IJOPE Paper JC-708 -- Accepted

IJOPE Paper No. JC-708 "Simplified Approach on the Ultimate Hull Girder Strength of Asymmetrically Damaged Ships"

Congratulations! It is a pleasure to inform you that your revised paper has been accepted for publication in the *International Journal of Offshore and Polar Engineering (IJOPE)*. We have also decided to publish a brief formal Discussion of your paper with comments from Reviewer 3 and your reply.

Fig. 11 Comparison of residual hull girder strength between the simplified method and the progressive collapse analysis

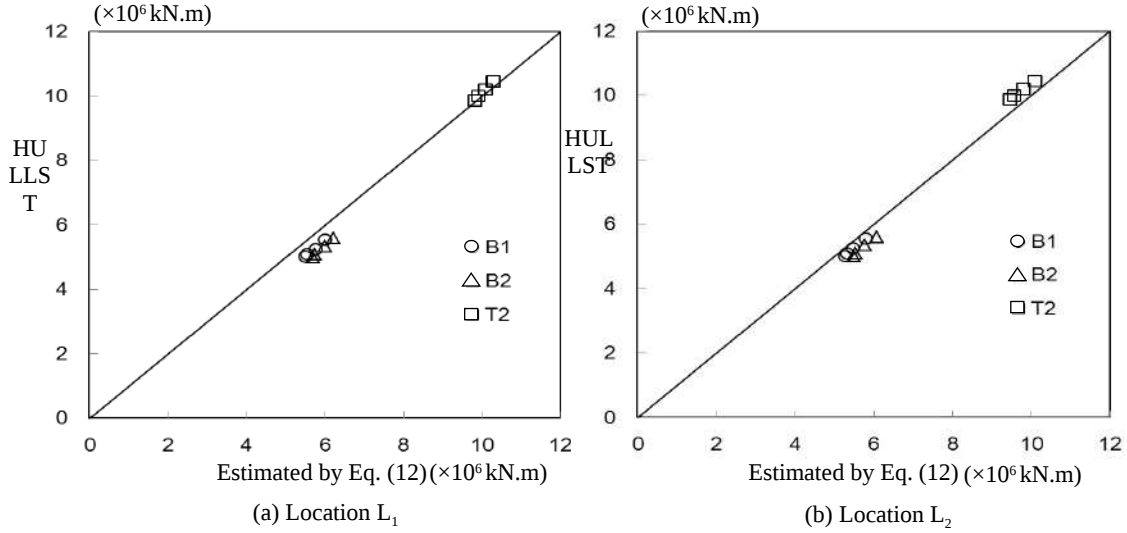
P.4; Fig. 11 (b): The overlapping of letters has to be revised.

The figure (b) in Fig.11 is digit shifted. Please correct it.

Has been revised, see the article.

Fig. 11 Comparison of residual hull girder strength M_V between the simplified method and the progressive collapse analysis

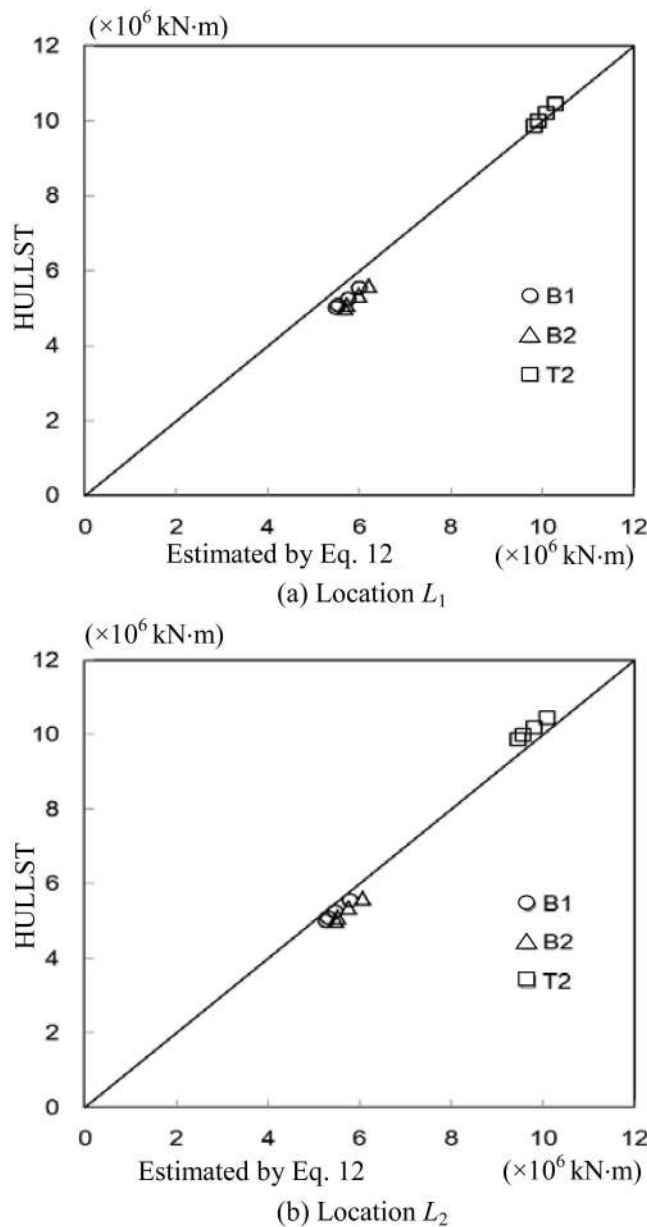
If you add captions in Fig.11 and Fig.12, they will be easier to recognize.

Captions on Fig.11 and Fig. 12 have been added.

Fig. 12 Comparison of reduction ratio of residual hull girder due to rotation of neutral axis between the simplified method and the progressive collapse analysis (Case 1/Case 2)

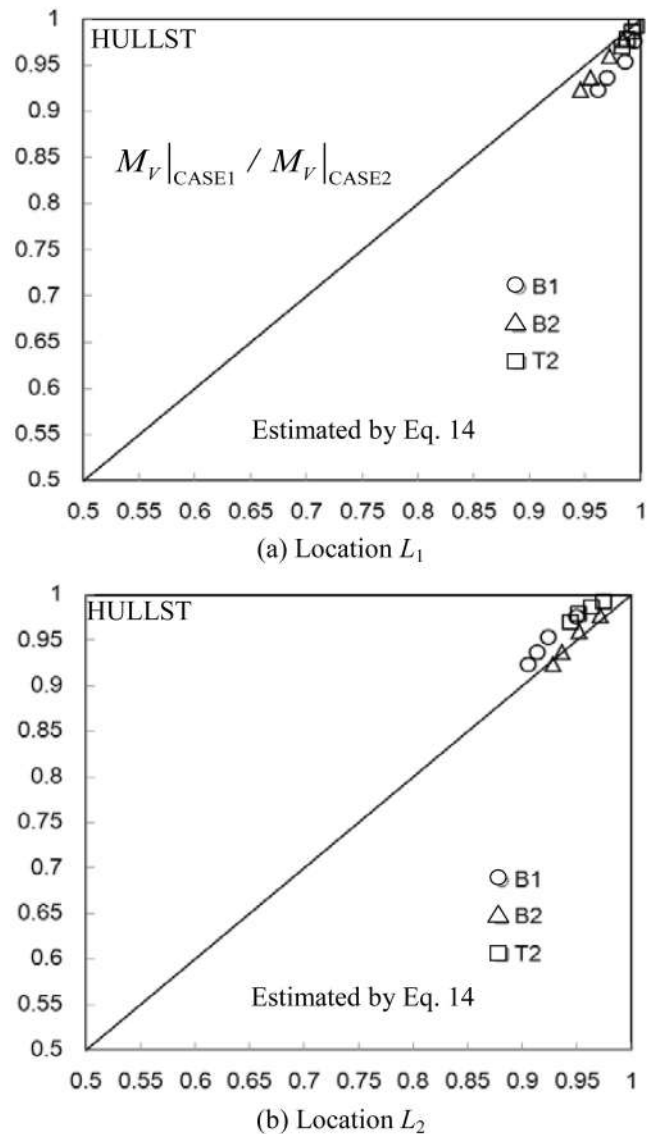
P.5; Fig. 12 (b): The overlapping of letters has to be revised.

- (44) Page 6; Fig. 12: “**Estimate** by Eq.(13)” → “**Estimation** by Eq.(14)” or “**Estimated** by Eq.(14)”
- (45) Page 6; CONCLUSIONS; 6th line: “**due to**” → “**considering**”
- (46) Page 6; CONCLUSIONS; 13th - 17th line “The ultimate strength becomes higher.” → This sentence is recommended to delete with the same reason described in (32).
- (47) Page 6; CONCLUSIONS; 17th line: “The effect is largest” → “The effect **of the rotation of neutral axis** is **the** largest”

Has been revised, see the article.
